Project Name:	Cinders Nursery, Yapton
Document Reference:	125.5005/SVR
Document Name:	SuDS Verification Report
Prepared By:	Ebenezer Akinkugbe (January, 2022)
Checked By:	Nadine Hassan (January, 2022)
Approved By:	Adan Shepherd (January, 2022)

Figure 1: Snip of 'As Built' Drawing Showing the Proposed Position of the Infiltration Trench Soakaways.

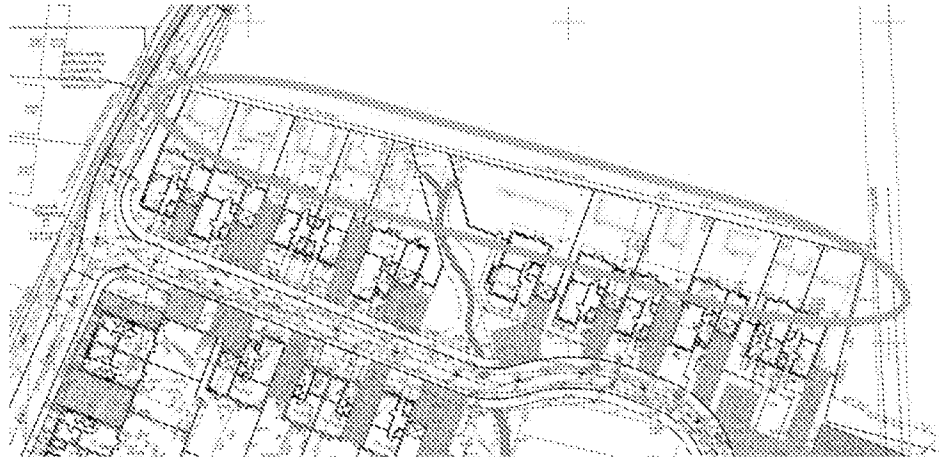
'As built' drawings show that plots 1 – 11 were to have infiltration trench soakaways installed in their rear gardens. See **Figure 1**. As all of the infiltration trenches are in the rear gardens of dwellings which were occupied at the time of site visit, it was not possible for Paul Basham

Associates to gain access to the trenches. However, Crayfern homes have provided Paul Basham Associates with photographs which show the excavated trench prior to it being backfilled with material for the Trench Soakaway. They show that the trench was laid with a geomembrane prior to it being backfilled. See **Figure 2** and **Figure 3**.

- 3.1 As Paul Basham Associates were not present at the time of installation, this report cannot confirm if the trenches were constructed in accordance with the agreed design. However, the site was attended shortly after a rain event and showed no signs of flooding in or around dwellings drained by Infiltration Trench Soakaways. No trees were noted in or around areas that would be detrimental to the infiltration soakaways.

Figure 4: Snip of As Built Showing the Proposed Position of Infiltration Crates

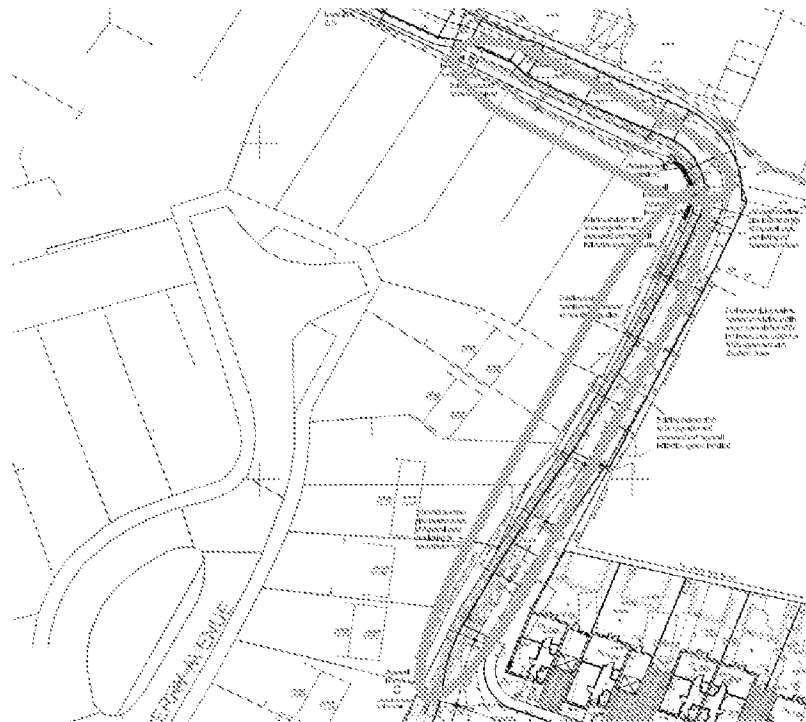
- 3.2 The 'as built' drawing indicates that a geocellular infiltration crate system is to be installed along Cinder's Lane. See **Figure 5** and **Figure 5**. Paul Basham Associates were not present during installation of the crates but were provided with photographs from Crayfern homes which show that the excavated trenches were laid with small stone aggregate, the crates were then laid and wrapped in a geomembrane. Pictures provided also show that the crates were then overlaid with small stone aggregate. See **Figure 6** and **Figure 7**.

Figure 8: Snip of the As Built Drawing showing the Proposed Position of the Permeable Block Paving.

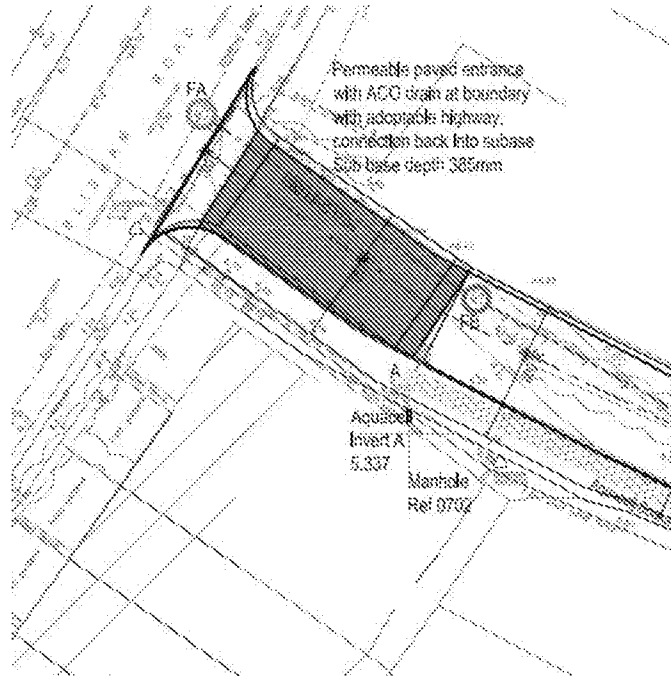
- 3.3 The 'As Built' drawing indicated that 20 sets of permeable block paving were installed. 17 of which were to be installed on private driveways, 1 on a shared driveway, 1 on a lay-by and 1 at the site access. This report can confirm that 19 out of 20 sets of permeable block paving sets were observed. **Appendix B** contains a picture of all sets of block paving installed on site. **Figure 8** shows

proposed position of the permeable block paving at the site access. **Figure 9** shows that upon site visit the permeable block paving has not been installed as per the As Built drawing.

Figure 10: Snip of As Built Showing Proposed Position of the Geocellular Attenuation Crates

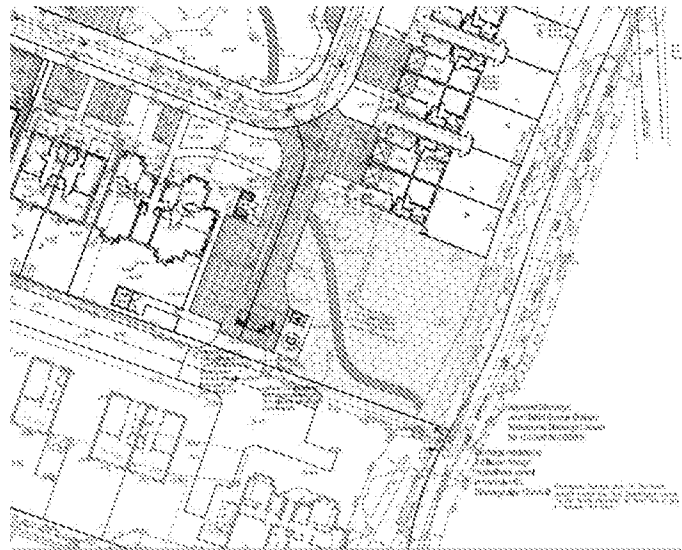
- 3.4 The as built drawings show that there is a set of Geocellular Attenuation Crates installed in the southeast corner of the site. See **Figure 10**. Paul Basham Associates did not attend the site during the installation of the crates however photographs taken during construction provided to Paul Basham Associates by Crayfern Homes show that the crates were underlain by an impermeable geomembrane. They also show that after being laid, the crates were then covered with an impermeable geomembrane and then a small stone aggregate. See **Figure 11**, **Figure 12**, and **Figure 13**.

- 3.5 It was not possible for Paul Basham Associates to confirm the size of the crates installed on site. No trees were observed in areas that would be detrimental to the geocellular crates.

Figure 14: Photograph of Hydrobrake Flow Control Device

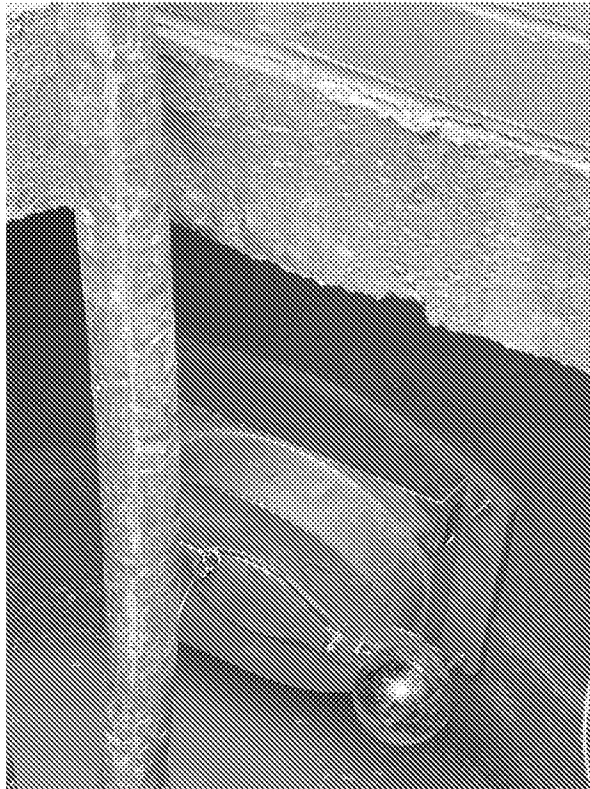
- 3.6 It was not possible to gain access to the Hydrobrake during the site visit. However, a photograph provided by Crayfern Homes (**Figure 14**) shows that a Hydrobrake was installed. A photocopy of the invoice for the device is contained in **Appendix C**.

Figure 15: Snip of Missing Gully on As Built Drawing

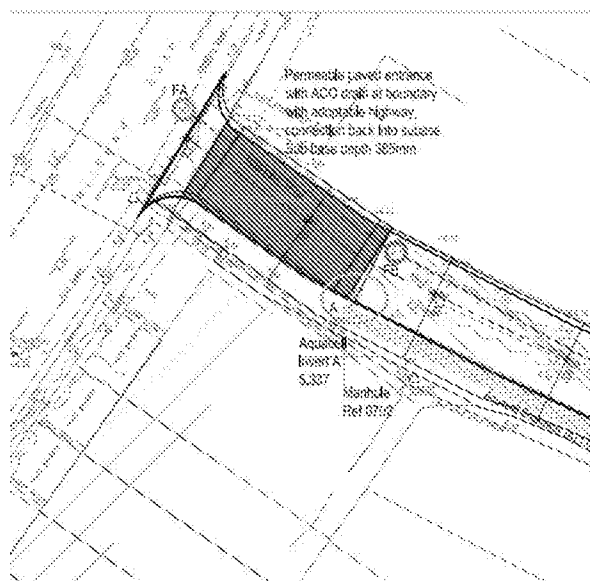
1. **Missing Gully A:** **Figure 15** shows the proposed position of the gully. **Figure 16** shows a photograph taken on site of the proposed position of the gully. It shows that no gully has been installed at the time of the site visit.

- 4.1 **Missing Gully A:** **Figure 27** below shows a stoned-up excavation for a gully in the proposed position of Missing gully A.

Figure 17: Snip of Missing Gully on As Built Drawing

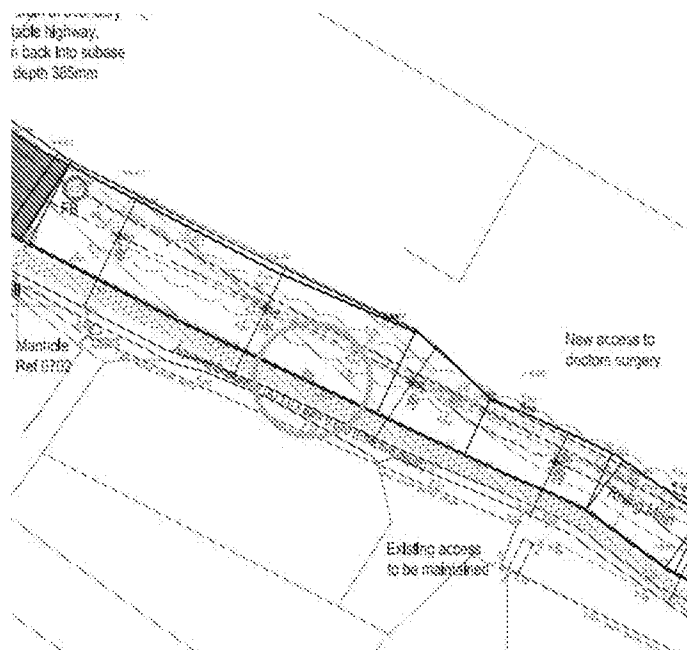
2. **Missing Gully B:** **Figure 17** shows the proposed position of the gully. **Figure 18** is a photograph of the proposed position of the gully. No gully could be observed at the time of site visit.

- 4.2 **Missing Gully B:** Figure 28 below shows a stoned-up excavation for a gully in the proposed position of Missing gully B.

Figure 19: Snip of Missing Gullies on As Built Drawing

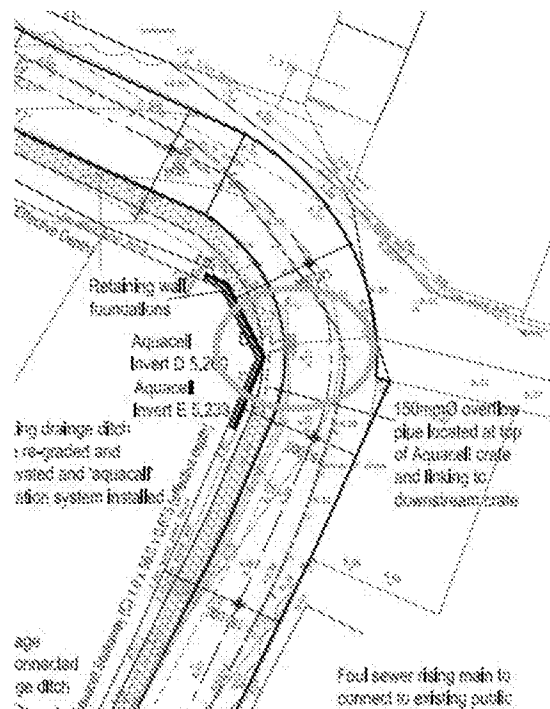
3. **Missing Gully C:** **Figure 19** shows the proposed position of the gully. **Figure 20** is a photograph of the proposed position of the gully. No gully could be observed at the time of site visit.

- 4.3 **Missing Gully C:** Figure 29 below shows a gully installed in the proposed position of Missing gully C.

Figure 21: Snip of Missing Gully in As Built Drawing

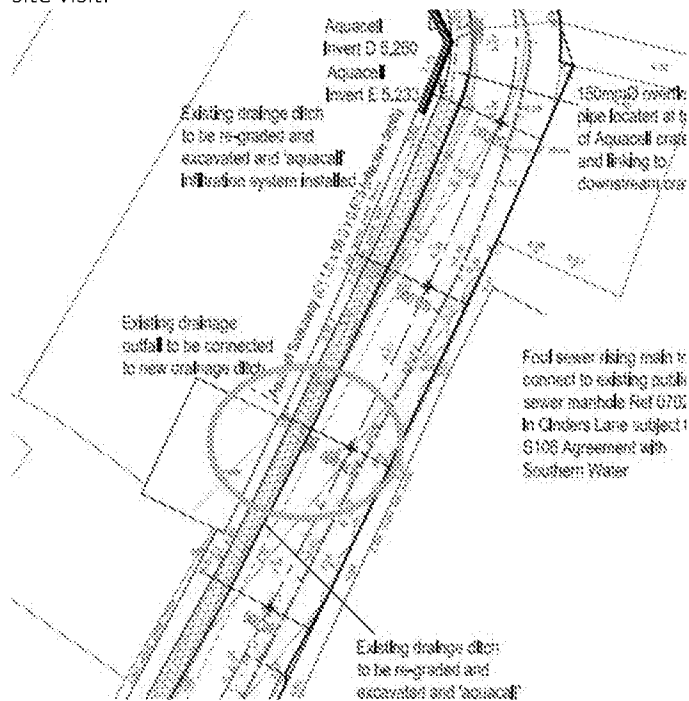
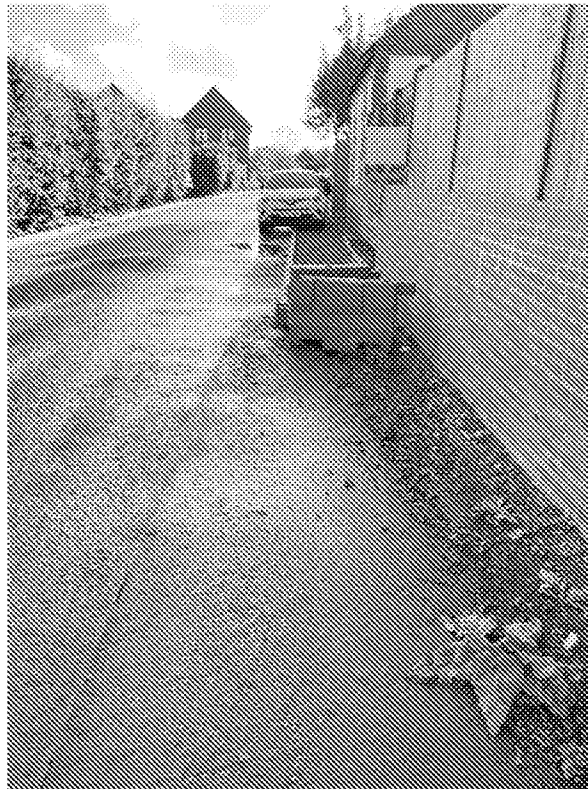
4. **Missing Gully D:** **Figure 21** shows the proposed position of the gully. **Figure 22** is a photograph the proposed position of the gully. No gully could be observed at the time of site visit.

Figure 23: Snip of Missing Gully in As Built Drawing

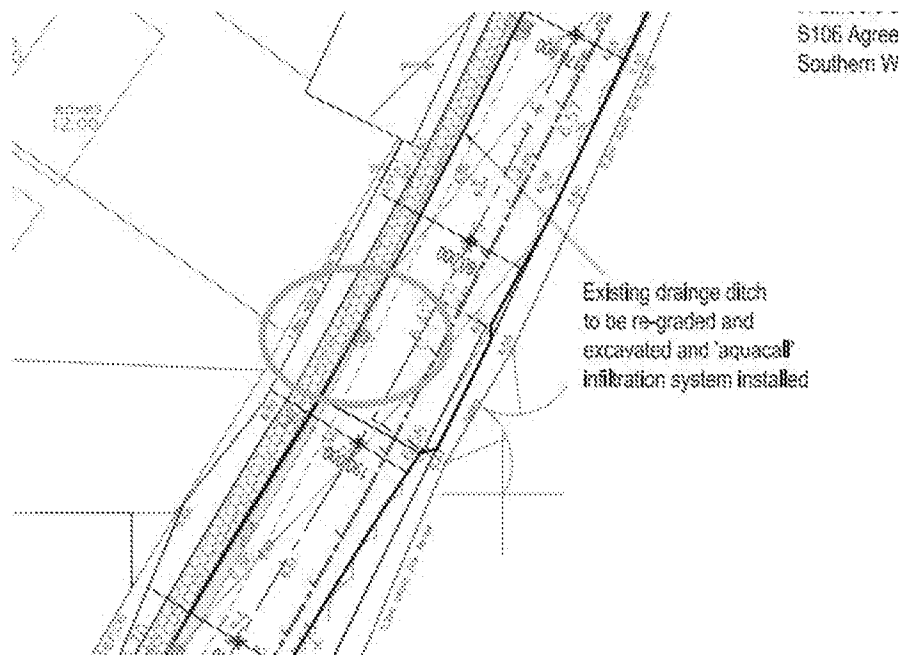
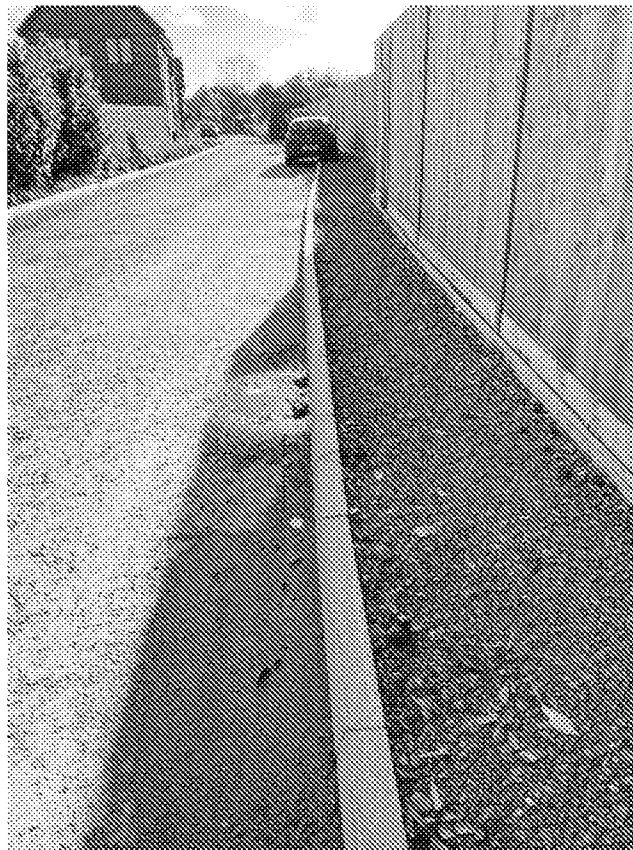
5. **Missing Gully E:** **Figure 23** shows that the proposed position of the gully. **Figure 24** is a photograph of the proposed position of the gully. No gully could be observed at the time of site visit.

- 4.4 **Missing Gully E:** **Figure 30** below shows a stoned-up excavation for a gully in the proposed position of Missing gully E.

Figure 25: Snip of Missing Gully in As Built Drawing

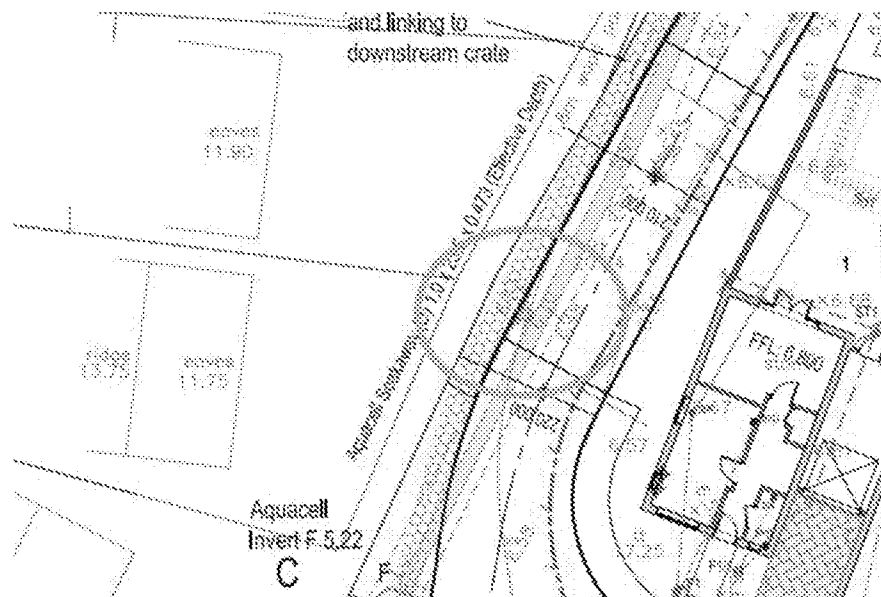
6. **Missing Gully F:** **Figure 25** shows the proposed position of the gully. **Figure 26** is a photograph of the proposed position of the gully. No gully could be observed at the time of site visit.

- 4.5 **Missing Gully F:** Figure 31 below shows a stoned-up excavation for a gully in the proposed position of Missing gully F.
